STATE	FISCAL YEAR	SHEET NO.	TOTAL SHEETS
HAW.	1972	3	29

BEGINNING OF PROJECT
Proj. No. 240A-01-67

BEG. OF PROJ. 240A-02-71
Sta. 183+50

PLATE 1, PLAN-PROFILE
KOFFEL & ESSER CO.

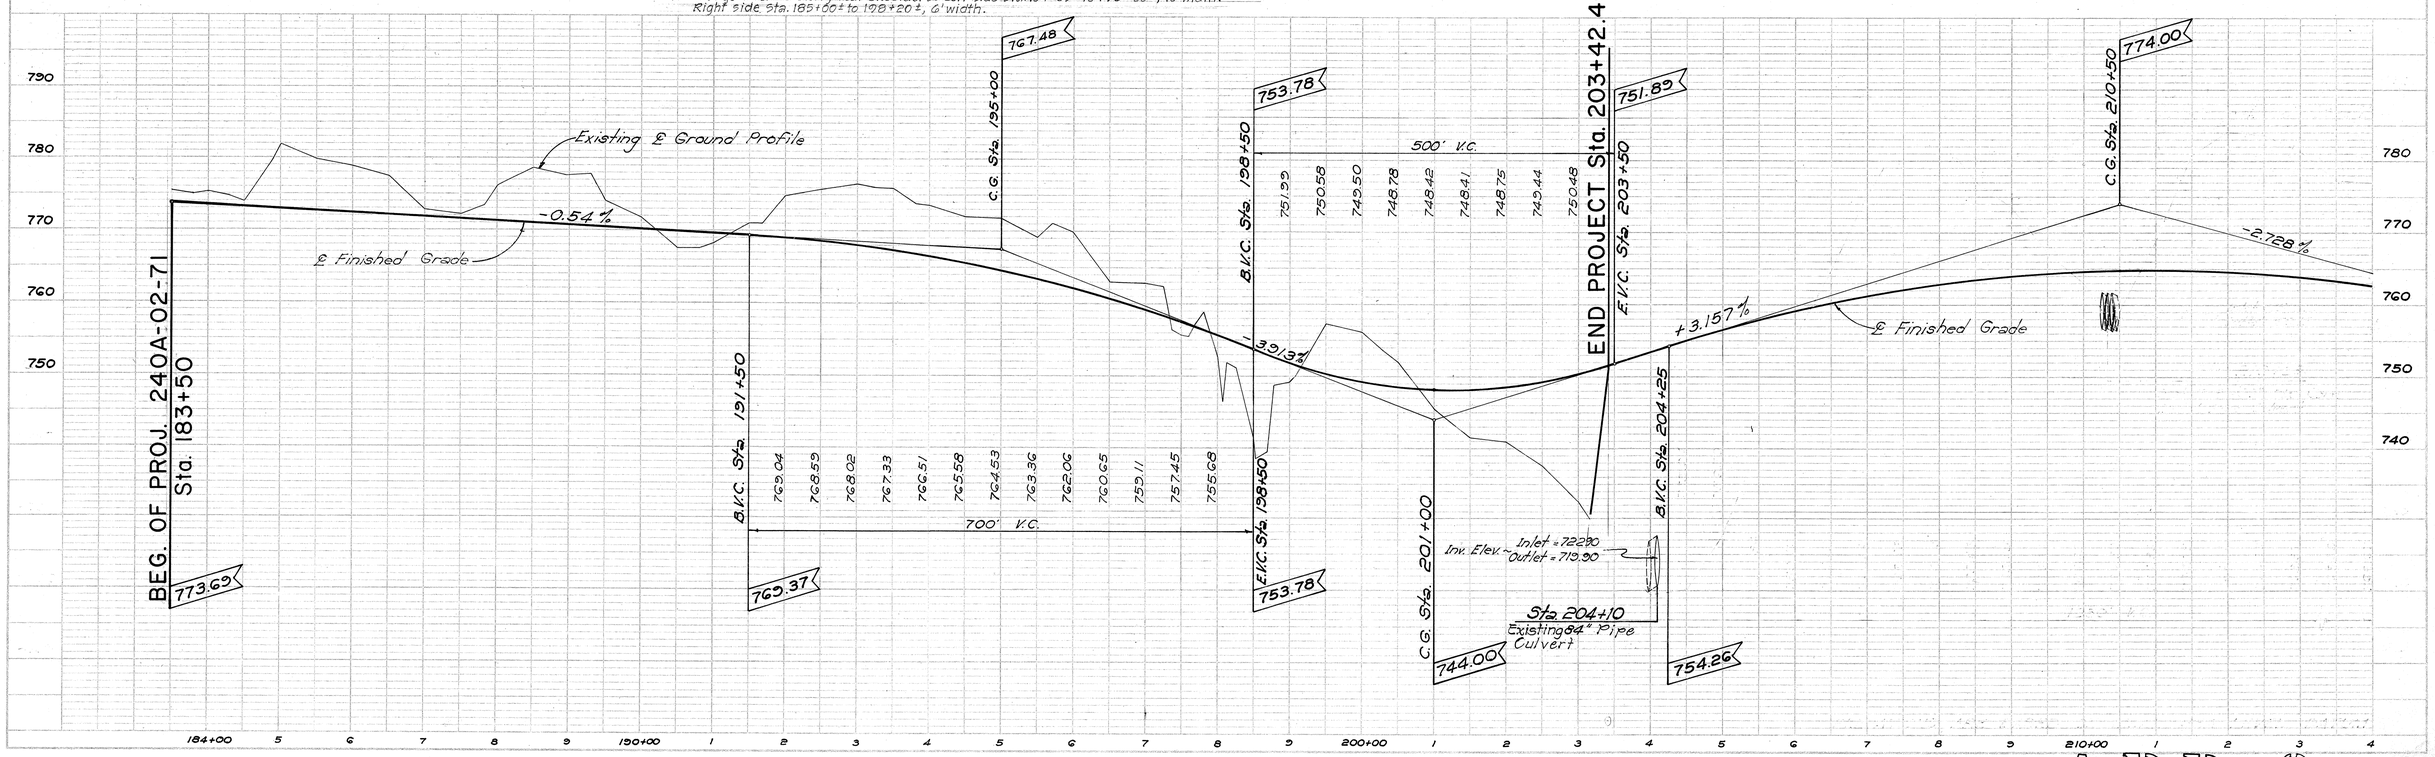
~~Sta. 198+67.85 to 203+42.40~~
~~Removal of temporary connection is considered incidental to the various contract items of work.~~

Change Order #1
Construct a Private
Driveway for Lot #16

R2-1(25) Changed to
R2-1(35) and Moved
to Sta. 199+21

R4-1 Signs Eliminated

Sta. 191+~~44~~ 65
Construct Tractor Crossing, ~~50~~ 56' x 12'
For Details See Sht. No. 2

R2-1(45) Moved to Sta. 199+21

Sideroads Moved From
Sta. 200+90 Rt. & Lt. to
Sta. 201+10 Rt. & Lt.

~~Sta. 197+80± Lt. to Sta. 198+30± Lt. 50 L.F.~~
~~Sta. 197+85± Rt. to Sta. 198+25± Rt. 50 L.F.~~
~~Sta. 198+90± Lt. to Sta. 199+80± Lt. 150 L.F.~~
~~Sta. 198+85± Rt. to Sta. 199+60± Rt. 75 L.F.~~

Sta. 197+72± Lt. to Sta. 198+17± Lt. 41.3 L.F.
Sta. 197+72± Rt. to Sta. 198+12± Rt. 51.0 L.F.
Sta. 198+96± Lt. to Sta. 199+99± Lt. 103.8 L.F.
Sta. 198+91± Rt. to Sta. 198+45± Rt. 53.8 L.F.

~~Reconstructed Guard Rail~~
~~Sta. 201+00± Lt. to Sta. 203+40± Lt. 250 L.F.~~
~~Sta. 201+25± Rt. to Sta. 203+40± Rt. 225 L.F.~~
